RS-10-020

Byron Station, Units 1 and 2  
Facility Operating License Nos. NPF-37 and NPF-66  
NRC Docket Nos. STN 50-454 and STN 50-455

**Subject:** Additional Information Supporting Request for License Amendment Regarding Ultimate Heat Sink

**ATTACHMENT 1**  
**Response to Request for Additional Information**

Figure H-1: Scenario 8A

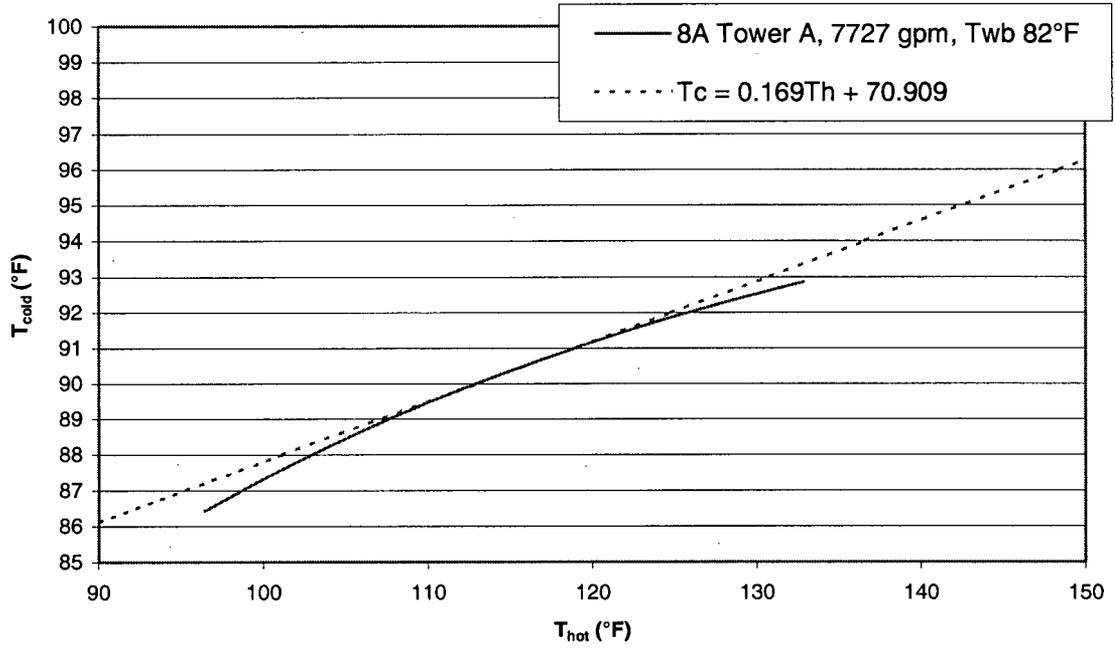
Response

For example in Accident Scenario 8A, the following points taken from the tower performance data are used (a curve of the data is shown in Figure H-1, the actual data points come from Calculation BYR97-127):

To accommodate actions that change the water flow distribution in the towers, the MathCAD model is setup for two time periods. In Scenario 8A, the first time period is time = 0 to 30 minutes and the second period is time  $\geq$  30 minutes. Th3 and Tc3 provide the tower performance data for Tower 1, and Th4 and Tc4 provide the tower performance data for Tower 2 during the second time period. MathCAD uses the input to calculate the slope and intercept for each tower for the second time period (M12, M22, B12 and B22).

For Scenario 8A there is no change in water flow distribution in the tower, thus Th1 = Th3, Tc1 = Tc3, Th2 = Th4, and Tc2 = Tc4.

Adding the MathCAD generated linear interpolation (M11=0.169 and B11 = 70.909) to the applicable Scenario 8A curve, it can be seen that the straight-line interpolation conservatively envelops the tower performance curve; i.e.,  $T_{cold}$  is conservatively high for a  $T_{hot}$  input value.

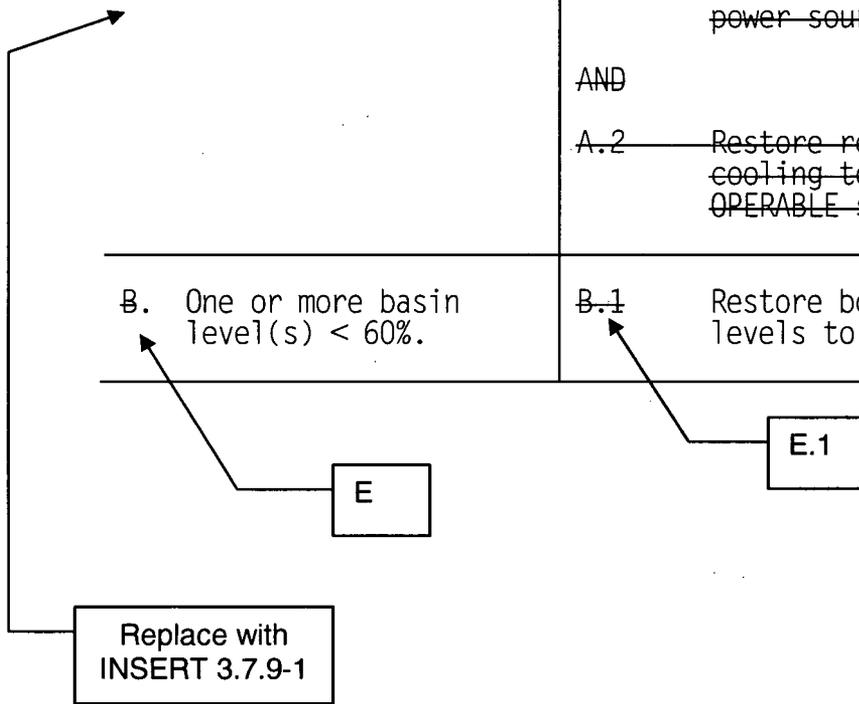
The fan requirements of the UHS are dependent on the SX pumps' discharge temperature. New TS Table 3.7.9-1 states these fan requirements and defines the associated Limiting Condition for Operation (LCO). Note (a) of this table could be construed to reduce the fan requirement when in Condition B. Since this note is associated with the column of the table that specifies LCO requirements, an interpretation of Note (a) could imply that the fan requirements for the LCO are satisfied if in Condition B and there is one less fan running in high speed. Then one might conclude the plant is no longer in Condition B. This could present confusion as to the actual condition of the UHS.

Furthermore, Condition A explicitly states that if one or more required cooling tower fans are not running in high speed, then actions must be taken immediately to correct the condition and, if not corrected immediately, then Condition J should be entered and the plant must be shutdown. This would mean that when the plant was running high speed fans to meet the LCO requirements of Table 3.7.9-1 with the other fans out of service, failure of one or more of the running fans would cause entry into Condition J and Mode 3 in 6 hours. The same situation would exist if SX temperature increased such that an additional fan in high speed was required in accordance with Table 3.7.9-1 and an additional fan was not available.

In response to the concern for possible misinterpretation with Note (a) of Table 3.7.9-1 and its relationship to Conditions A and B, Note (a) has been eliminated from Table 3.7.9-1, and Condition A has been reworded to read "One or more OPERABLE cooling tower fan(s) not running in high speed as required by Table 3.7.9-1." The proposed note for Condition A has also been eliminated. As defined in the TS Bases, an operable cooling tower fan must be capable of running in high speed. If Table 3.7.9-1 requires operable cooling tower fans to be running in high speed and one or more are not, then required Action A.1 would direct actions to be initiated immediately to place those required operable fan(s) that are currently operable in high speed mode. If Table 3.7.9-1 requires operable cooling tower fans to be running in high speed and one required fan is not capable of running in high speed, then the fan is considered inoperable. In this case, Condition B would apply. Condition A would not apply to this situation, since the fan is not operable. If Table 3.7.9-1 requires operable cooling tower fans to be running in high speed and more than one required fan is not capable of running in high speed, then these fans are considered inoperable. In this case, Condition J would apply.

Table 3.7.9-1 has been revised to encompass all SX pump discharge temperature ranges. Subsequently, the word "ADDITIONAL" has been removed from the heading of the second column of Table 3.7.9-1, and SR 3.7.9.2 has been revised to read "Verify cooling tower fan requirements in Table 3.7.9-1 are met."

The LCO statement has been revised to state "The UHS shall be OPERABLE and the SX cooling tower fans shall be OPERABLE and operating as specified in Table 3.7.9-1." This revision ensures consistency with other LCOs that contain tables that further define the LCO requirements. In addition, a typographical error was corrected in Required Action B.2; the word "fans" has been changed to "fan."

Condition C has been modified to read "Two inoperable cooling tower fans not required to be OPERABLE by Table 3.7.9-1 that are powered by the same electrical division." Attachment 2 provides the revised markups of the affected TS pages.
